**SOLICITATION AMENDMENT  
MODIFICATION DE L'INVITATION**

<b>Title - Sujet</b> Office Furniture Transport Canada	
<b>Solicitation No. - N° de l'invitation</b> EZ884-201059/A	<b>Amendment No. - N° modif.</b> 002
<b>Client Reference No. - N° de référence du client</b> EZ884-201059	<b>Date</b> 2019-10-25
<b>GETS Reference No. - N° de référence de SEAG</b> PW-\$VIC-216-7836	
<b>File No. - N° de dossier</b> VIC-9-42137 (216)	<b>CCC No./N° CCC - FMS No./N° VME</b>
<b>Solicitation Closes - L'invitation prend fin</b> <b>at - à 02:00 PM</b> <b>on - le 2019-10-31</b>	<b>Time Zone</b> <b>Fuseau horaire</b> Pacific Daylight Saving Time PDT
<b>F.O.B. - F.A.B.</b> <b>Plant-Usine:</b> <input type="checkbox"/> <b>Destination:</b> <input type="checkbox"/> <b>Other-Autre:</b> <input type="checkbox"/>	
<b>Address Enquiries to: - Adresser toutes questions à:</b> Thorne, Darlene	<b>Buyer Id - Id de l'acheteur</b> vic216
<b>Telephone No. - N° de téléphone</b> (250) 216-3168 ( )	<b>FAX No. - N° de FAX</b> ( ) -

***SOLICITATION AMENDMENT 002 IS RAISED TO POST ANSWERS TO ENQUIRIES (Q&As) AND TO AMEND THE SOLICITATION AS FOLLOWS:***

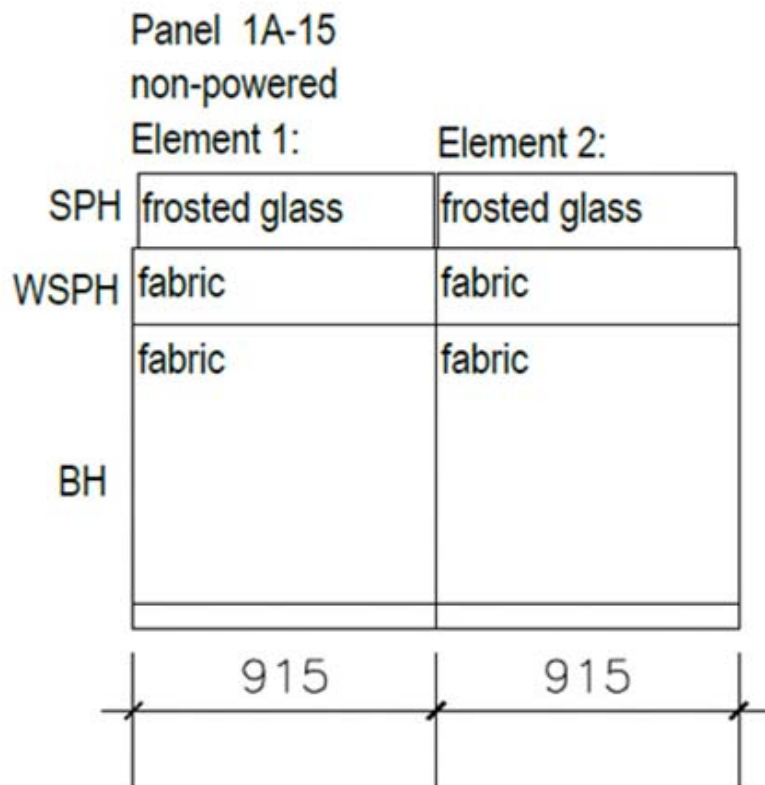
**Q12:** I have a question regarding panel 1A-15. The description is asking for a seated privacy panel with frosted glazing for the upper elements.

But, the drawing is asking for a fabric upper, then glass upper for a seated privacy overall height.

Do you want us to quote what is shown in the drawing, or what you are asking for in the table?

**A12:** Please have the bidder quote what's in the table description. The Upper Element should only be frosted glass.

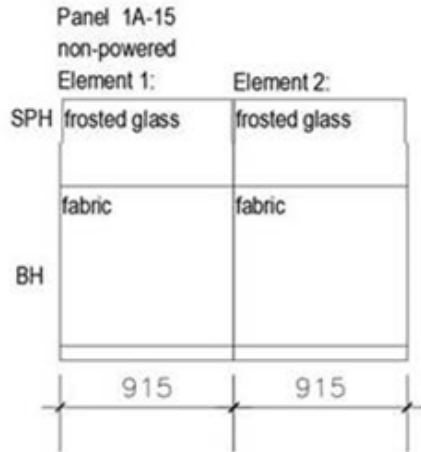
**Q13:** “1) Workstations WS1-61, 63, 65, 67, & 69 is showing a 1A-10 panel to go against the exterior wall. I believe these are meant to be 1A-11.

**A13:** The potential bidder is correct. WS-61, 63, 65, 67 & 69 should be 1A-11.

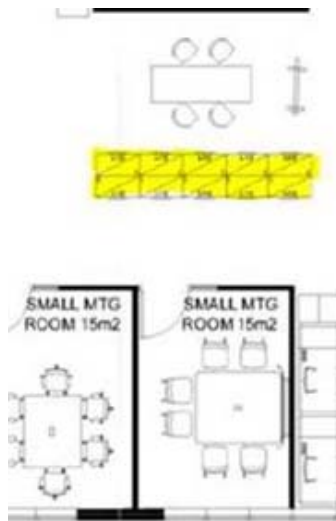
Q16: Please advise the locations of 1B11-NSA worksurface and 2-08NSA modular height adjustable bench.

A16: 1B-11NSA – These worksurfaces will be placed on top of relocated 3-high file cabinets and affixed by double-sided tape. The location is between a collab area and the Small Meeting rooms 232 & 233. Please see yellow highlighted area in attached clip.

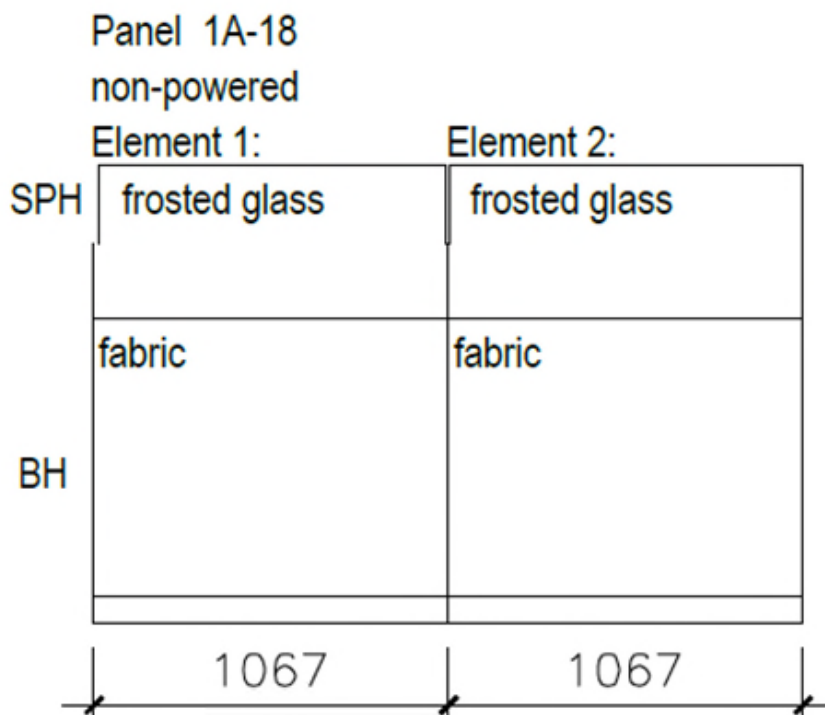
Q22: Panel 1A-18 is asking for accessory rails for the upper elements.

But the drawing is showing glass.

A22: The description in the list is accurate. There will be Accessory Rails for Upper Element 1 and Upper Element 2. The drawing should say Accessory Rail for both upper elements as shown in the attached image.
